Subject: Duke Energy Corporation
Oconee Nuclear Station - Units 1, 2, and 3
Docket Nos. 50-269, 50-270, and 50-287

Revisions to Topical Report DPC-NE-3003 In Support of
Steam Generator Replacement
Response to NRC Staff Request for Additional
Information

Duke Power Response To Request For Additional Information

DPC-NE-3003 Revision 1 “Mass and Energy Release and Containment Response Methodology”

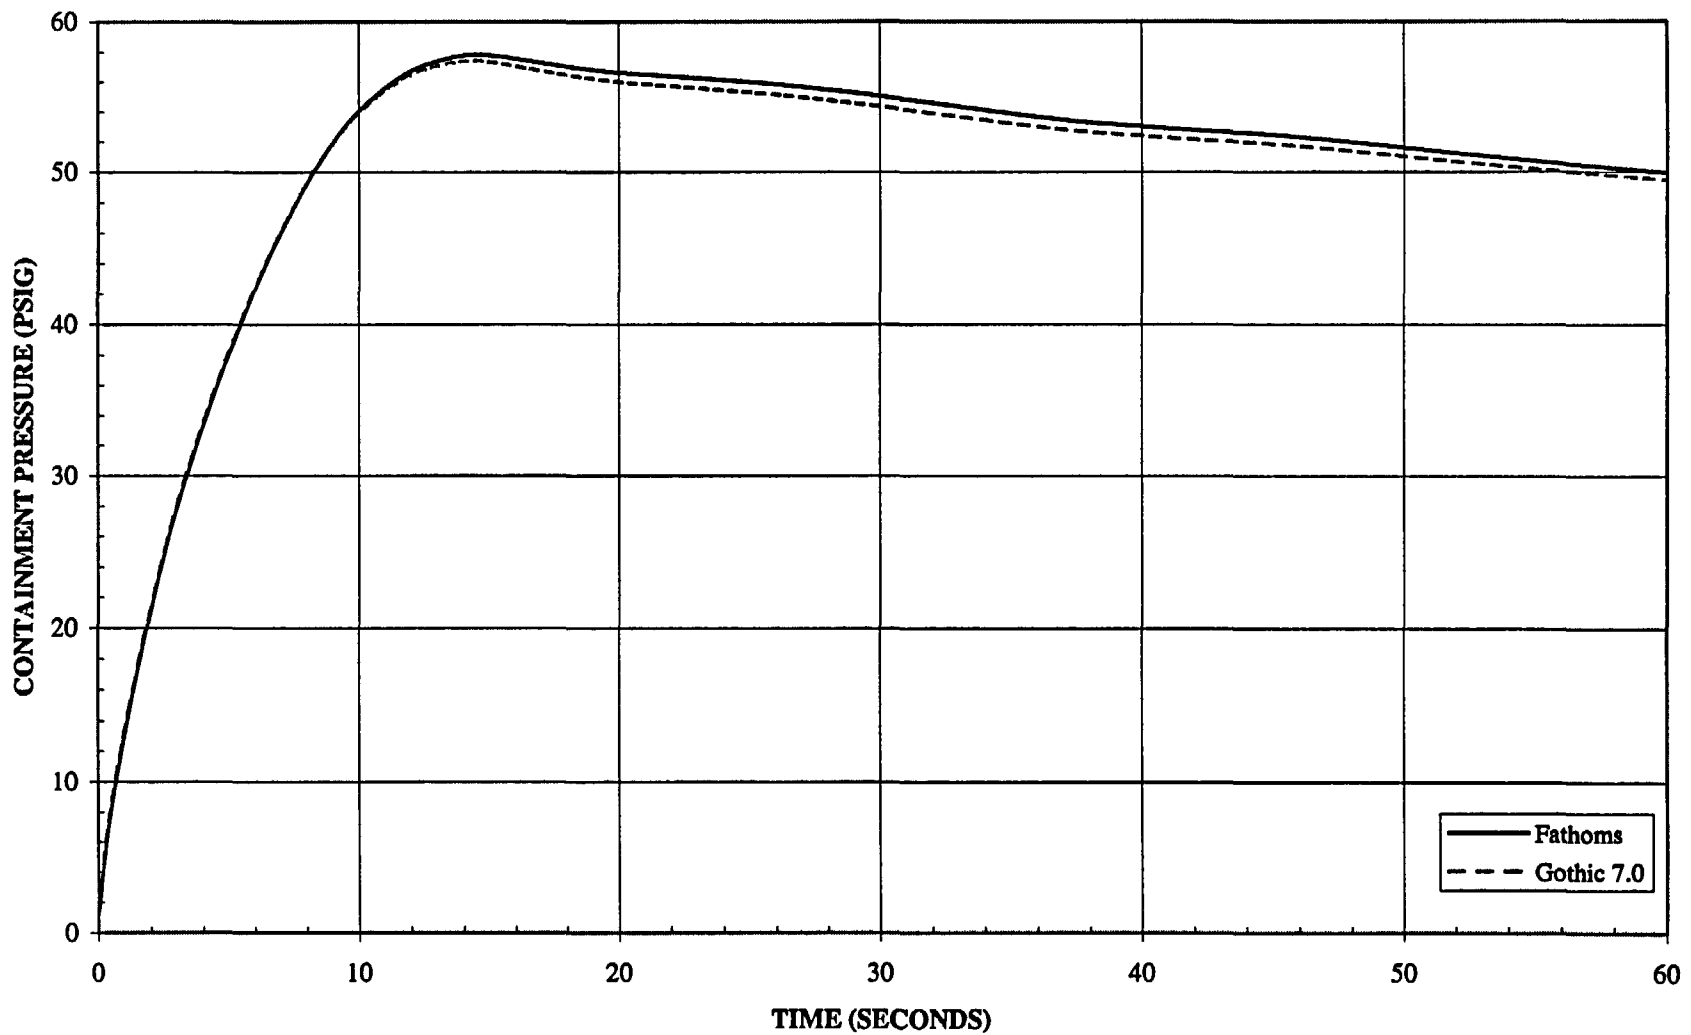
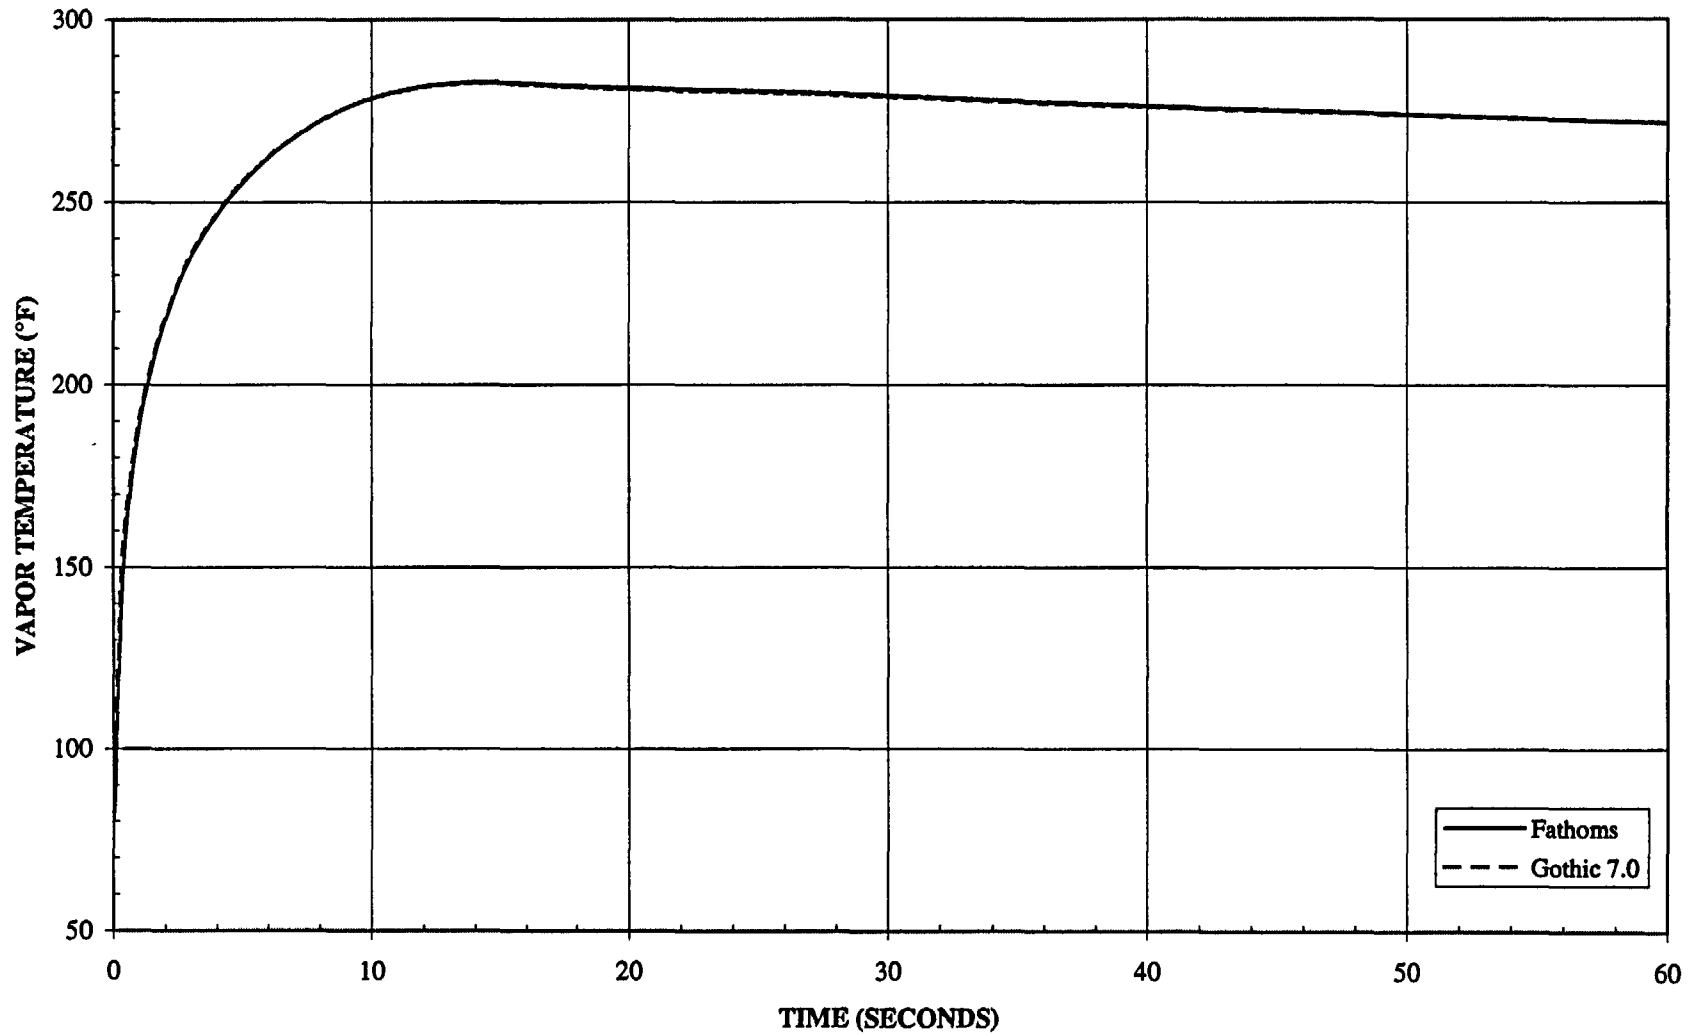
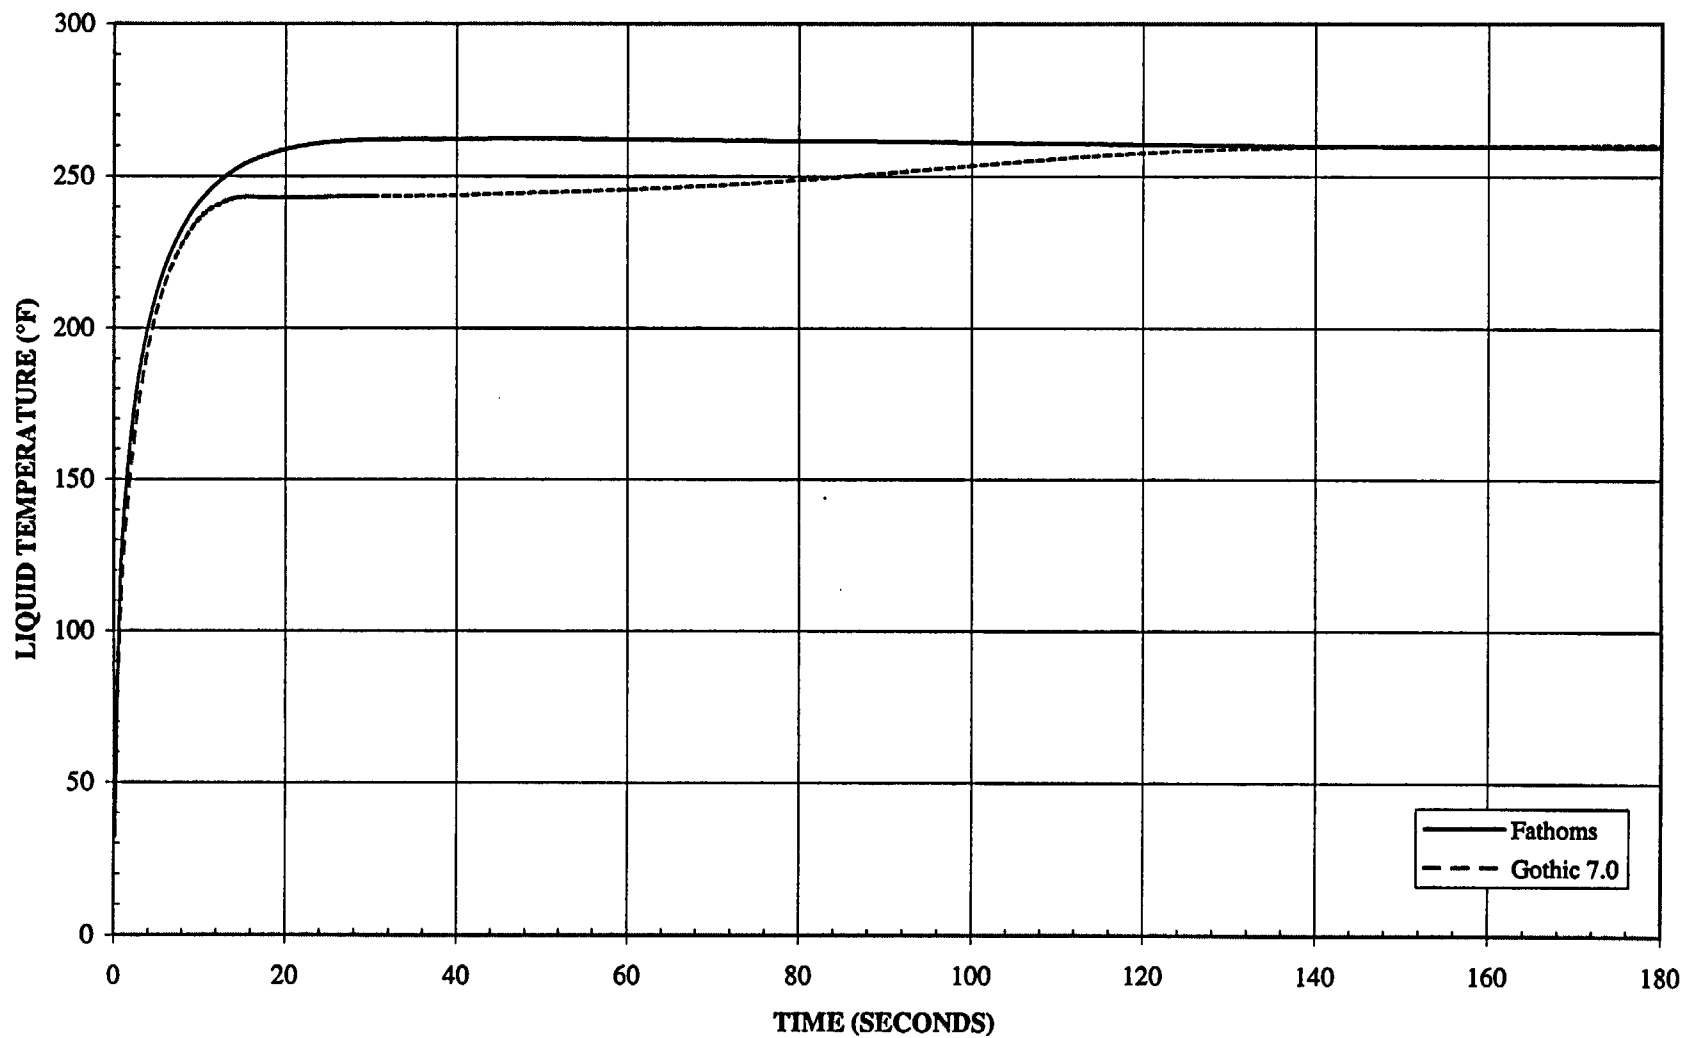
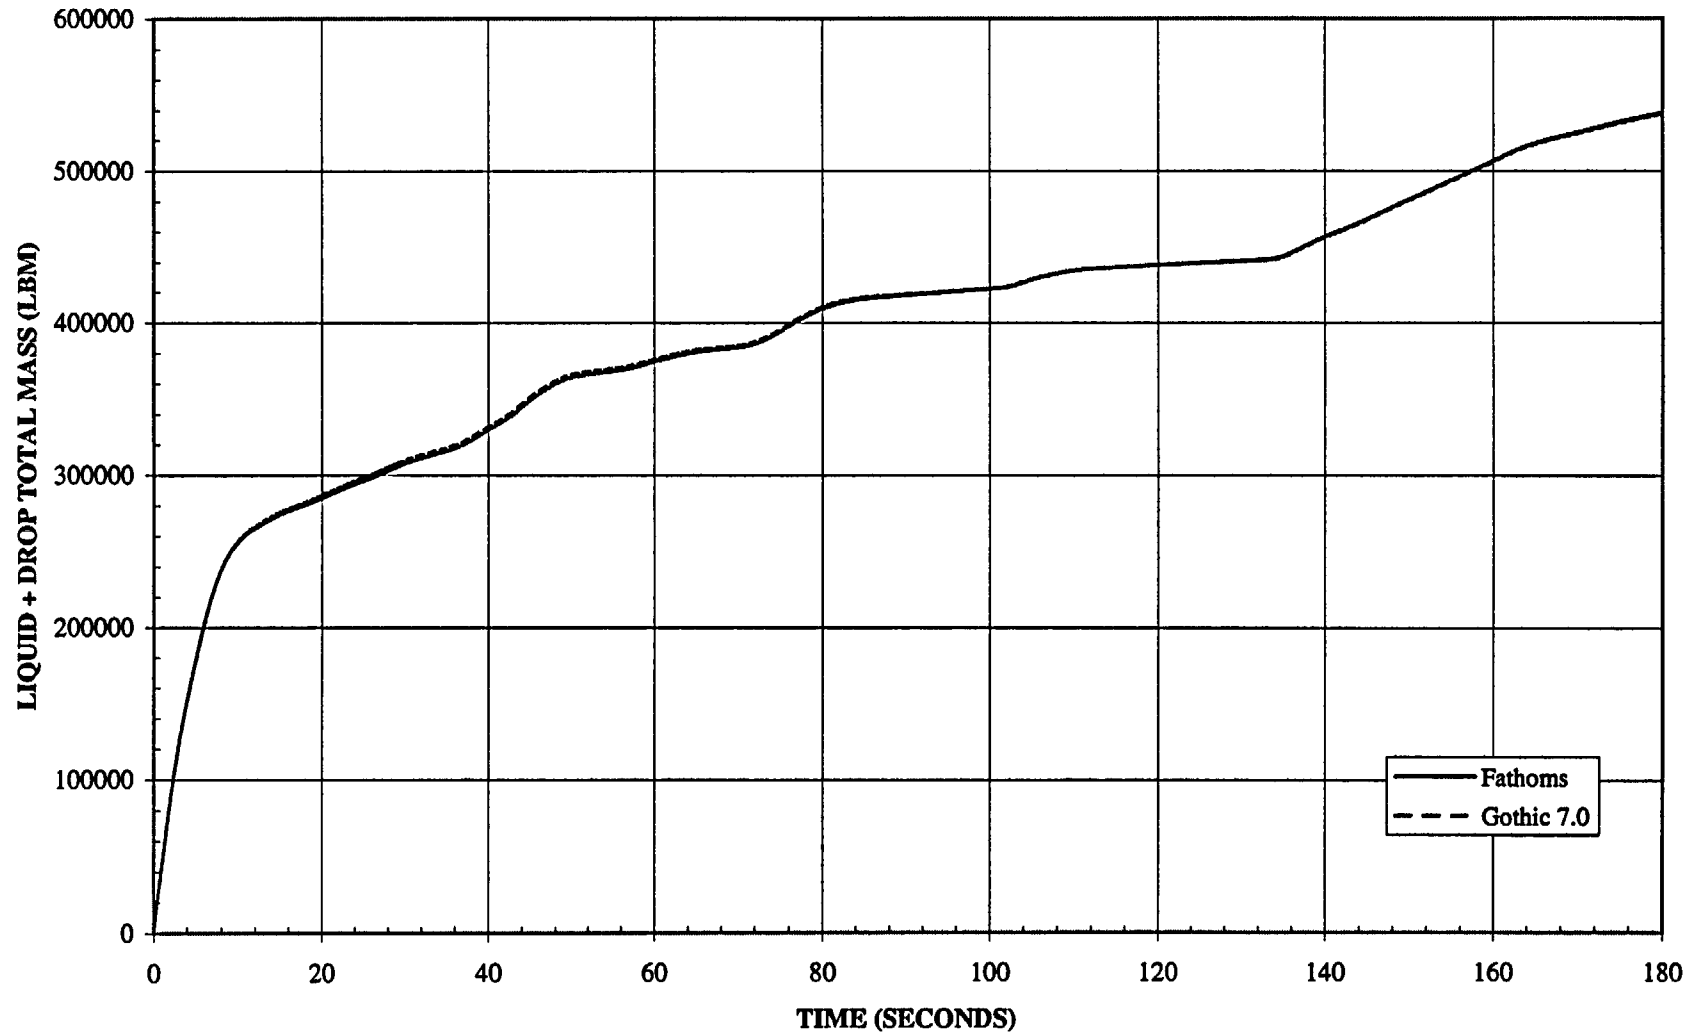
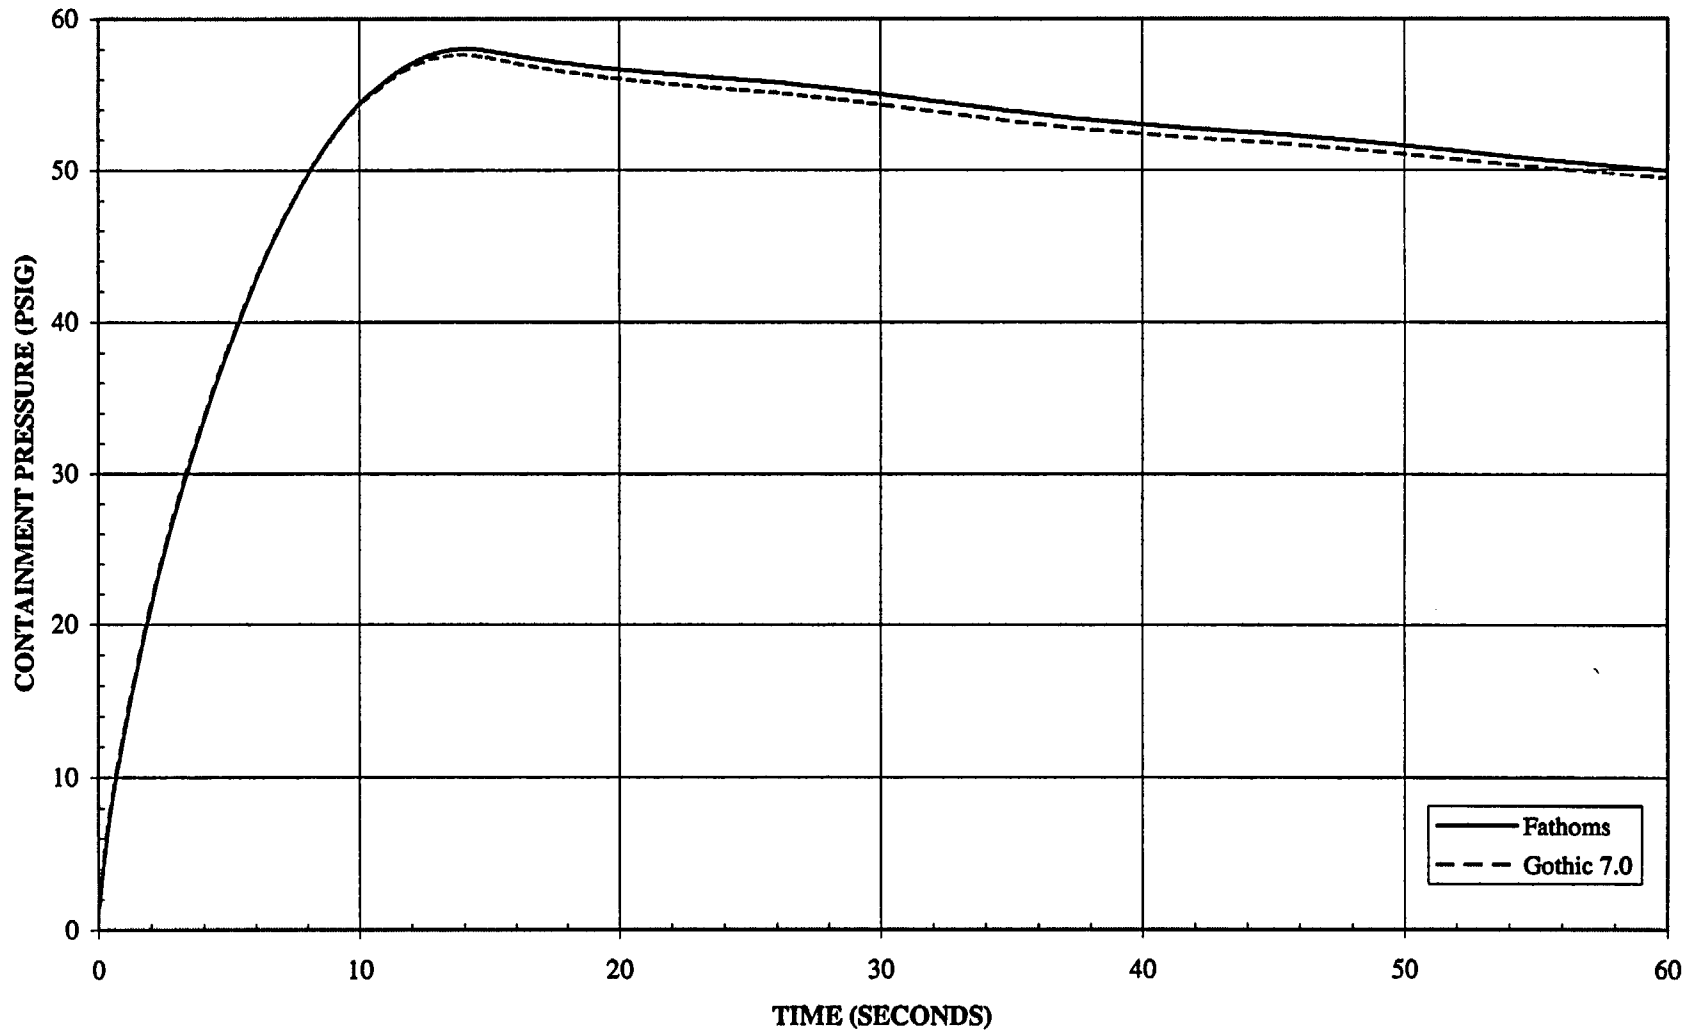
3. Please provide the results using the GOTHIC 7.0 code of peak pressure and temperature calculations for the sensitivity cases listed in Table 3.1-1 of DPC-NE-3003 in tabular and graphical form. If the results or conclusions are significantly different from those presented in DPC-NE-3003P, explain the difference.

Response: Table 3.1-1 of DPC-NE-3003 describes a spectrum of LOCA peak pressure cases including a range of break locations and sensitivity analyses for several important modeling assumptions. The staff's request is understood to focus on the difference in the predicted results from the FATHOMS and GOTHIC 7.0 code versions. Rather than show the comparison for the cases in Table 3.1-1, a different set of cases has been selected which is more focused on the current knowledge of the key sensitivity parameters. Also, the results presented are for the ROTSGs, which is the subject of Revision 1 to the topical report.

The results of the 14 code comparison analyses are shown in Table 3-1 below and in the figures that follow. In general, the pressure and vapor temperature response predictions were very similar in both magnitude and trend. GOTHIC 7.0 predictions for peak pressures and vapor temperature were slightly lower (~0.5 psig and 0.5°F). These differences are consistent with the code model differences described in the response to Question #1. Both codes predict a saturated containment atmosphere due to the large amount of drops injected. The slightly lower pressure, vapor temperature, and liquid temperature from GOTHIC 7.0 may be attributed to additional drop hold up in the atmosphere. This effectively increases the heat capacity of the atmosphere and reduces the temperature rise for a given energy addition. A comparison of the total liquid and drop masses, and liquid temperatures, show the predictions of the two codes to be essentially the same. This is consistent with the changes in the drop deposition and entrainment models discussed in Question #1. These results show that the two code versions give essentially similar results for the same break location and initial and boundary conditions.
